**PLANNING REPORT IN ACCORDANCE WITH
SECTION 179 3(a) OF THE PLANNING & DEVELOPMENT
ACT 2000 (as amended)**

Golf Links Road Upgrade

Limerick City & County Council

Planning Reference No. 21/8006

Figure 4: Proposed speed ramps (drawing GLR-RT-D01 Rev C)

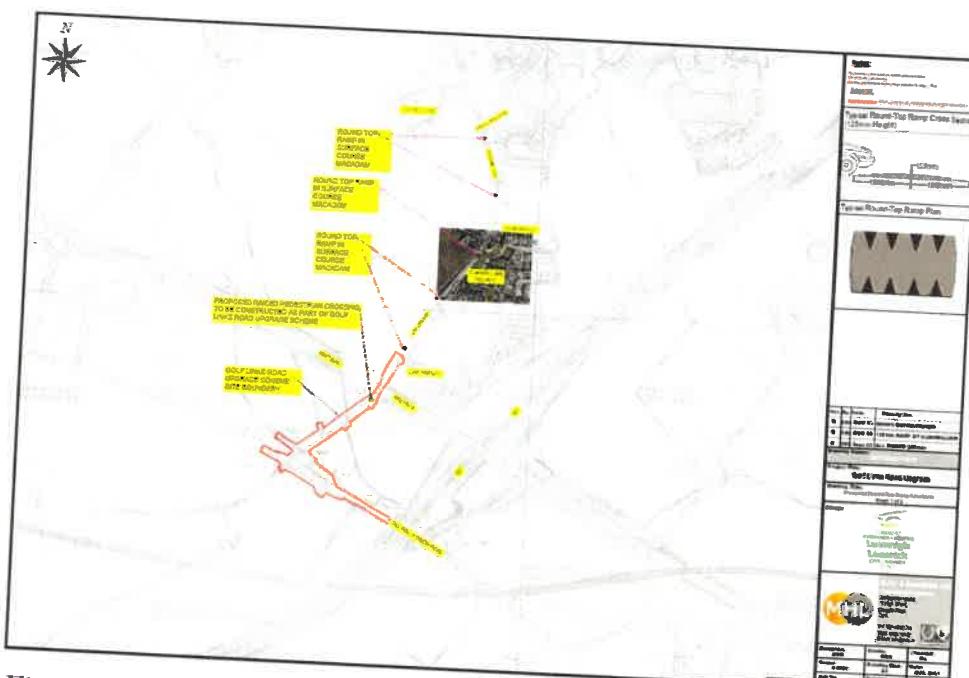
The proposed development has been amended to provide five number additional speed ramps on the Golf Links Road between Cairnsfort housing estate and School House Road as per drawing GLR-RT-D01 Rev C.

The respondent observes that *the proposed development will lead to increased traffic volumes and urges the council to give consideration to providing additional speed ramps along the lower half of the Golf Links Road.*

The proposed development has been amended to provide five number additional speed ramps on Golf Links Road between Cairnsfort housing estate and School House Road as per drawing GLR-RT-D01 Rev C.

4. The development shall provide for five number additional speed ramps on Golf Links Road between Cairnsfort housing estate and School House Road as per drawing number GLR-RT-D01 Rev C.
